Proposal how to structure the RESS safety requirements

Diagram 1 – minimum shock pulse

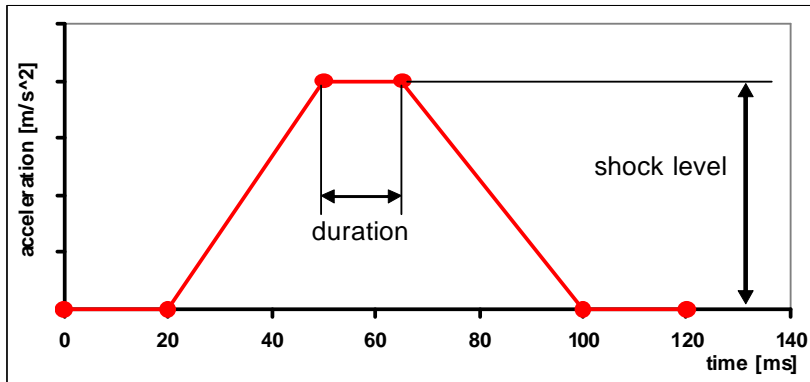
**Comment (Sweden) regarding M1 and N1 acceleration levels in Table 5**  
In their work in the European FIMCAR project the German group Verband der Automobilindustrie (VDA) have presented crash simulations (analogous to ECE R94) on Volkswagen, Mercedes E-class and Smart. Those acceleration levels indicate that the proposed acceleration pulse for M1 and N1 in Table 5 is exceeded by more than 50-100% in a full scale R94 vehicle crash test.

**Comment [T28]:**  
**Comment Sweden**  
Acceleration pulses in Diagramm 1 and 2 do not represent acceleration pulses equivalent to acceleration pulses generated in a R94 crash test with modern vehicle

Diagram 1  
M1, N1 Shock levels and duration in direction of travel

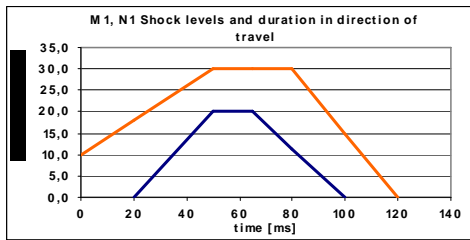
**Comment [TG31]:**  
**Comment Frontal Impact Informal Group & France Frontal impact test for M1, N1**  
The Proposal validated by the Frontal Impact informal group (GRSP) is to apply the R17 dynamic corridor.

**Justification:** the batteries anchorages shall undergo the same deceleration than the seats fixation points, Therefore they have to undergo the same test level.

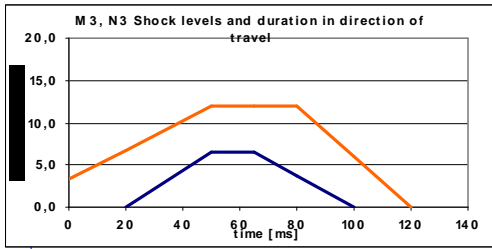
**Comment [TG32]:**  
**Comment Frontal Impact Informal Group & France Side impact test for M1, N1**

No existence of corridor corresponding to a R95 for component test. We studied a corridor based on our experience of R95 impact tests (average of several tests).

**Pulse proposal**  
The pulse into the corridor is a simulated pulse. ... [5]

M3, N3 Shock levels and duration in direction of travel

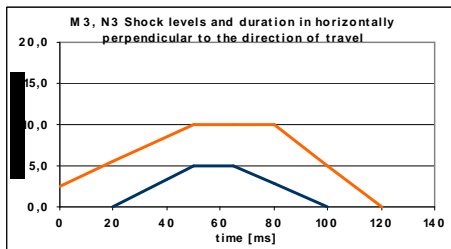
**Comment [TG33]:**  
**Comment Frontal Impact Informal Group & France Corridor for M2, N2 and M3, N3 frontal and side impact tests**

We agree with values from RESS 3-3 rev 1 (which are the same values introduced in R110 and R67). Furthermore, we have to define a hold time, and we propose to apply the hold time from R80, which is 50ms, for the M2, N2, M3 ... [6]
